**LESSONS LEARNED REPORT FROM THE THIRD
NATIONAL FIRE PROTECTION ASSOCIATION (NFPA) 805
PILOT PLANT OBSERVATION VISIT**

Date: November 6–9, 2006

Subject: Risk-Informed, Performance-Based Fire Protection Transition Pilot-Plant Observation Visit – Raleigh, North Carolina

Figure 1. Multiple Spurious Post-Transition Inspections

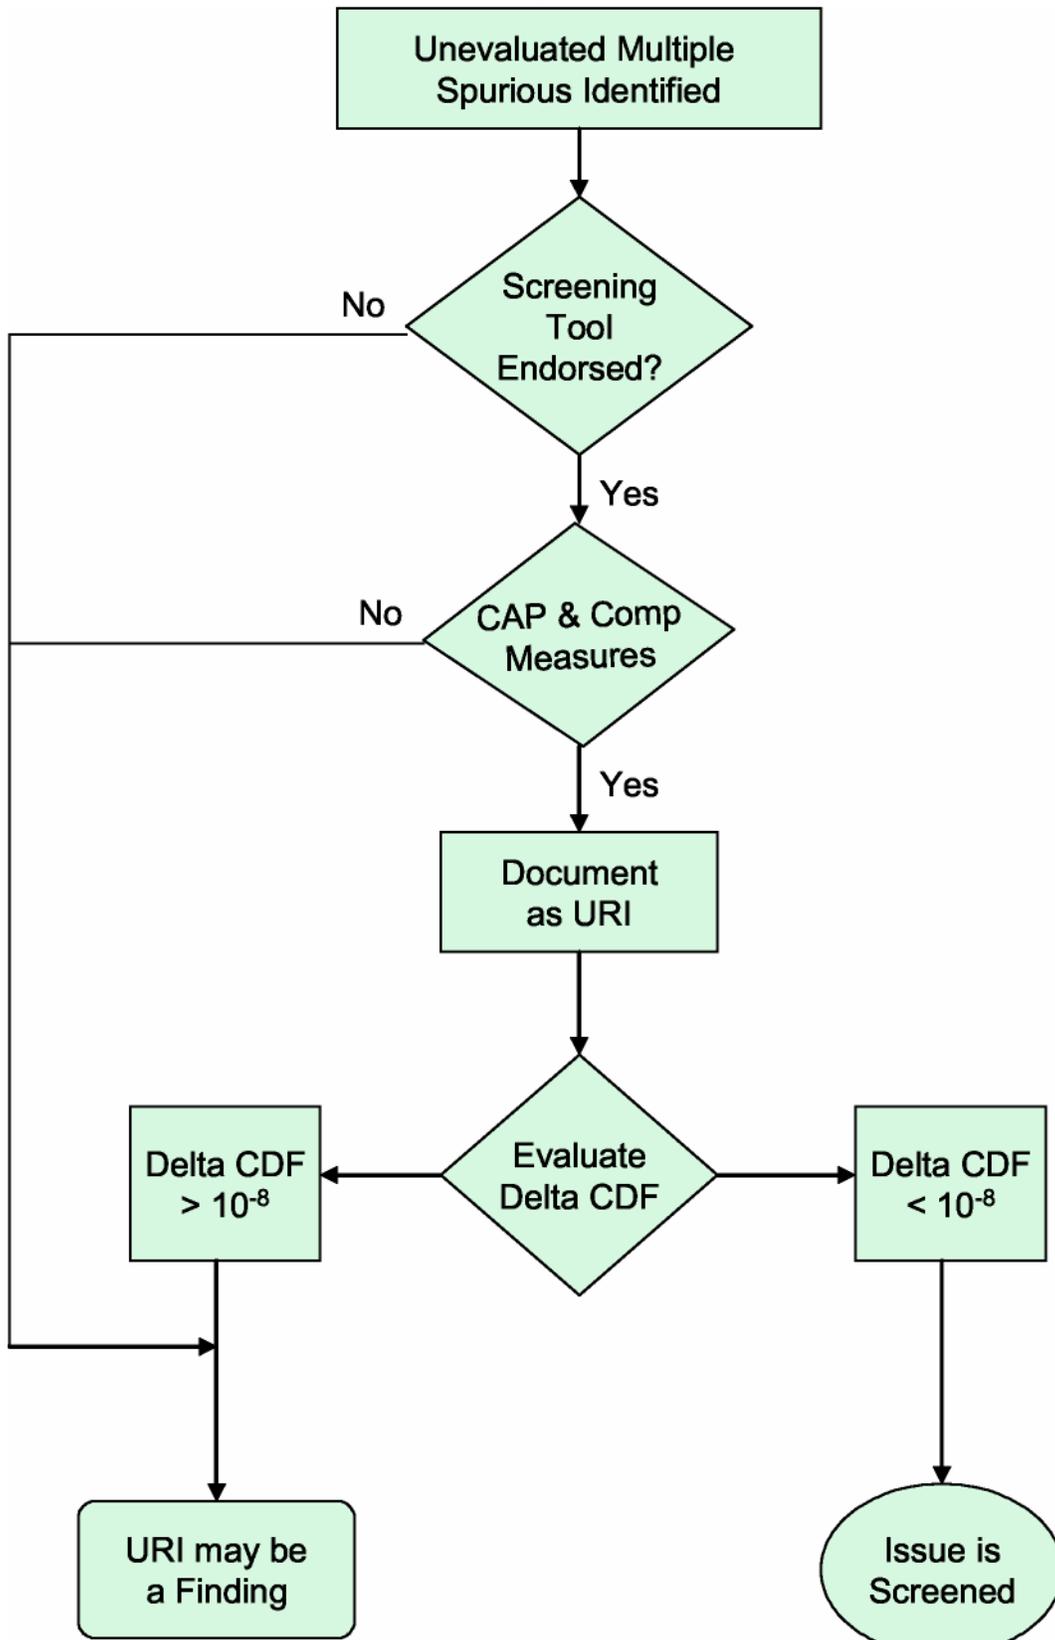
The NRC staff presented a flowchart during the March 2006 pilot plant observation meeting that illustrated how new multiple spurious operations (identified during inspections) would be treated. (See flow chart below.) The NRC staff also conveyed the following information during the meeting:

Chapter (IMC) 0612, and suggest development of new questions if necessary such that multiple spurious operations below a certain threshold are minor and treated accordingly.

Resolution Action(s)/Action Party: OPEN. Industry and pilot-plant participants agreed to review the flowchart, IMC 0612 questions, screening thresholds and provide feedback to the NRC at the next observation meeting. The industry may also submit an frequently asked questions (FAQ) on the issue.
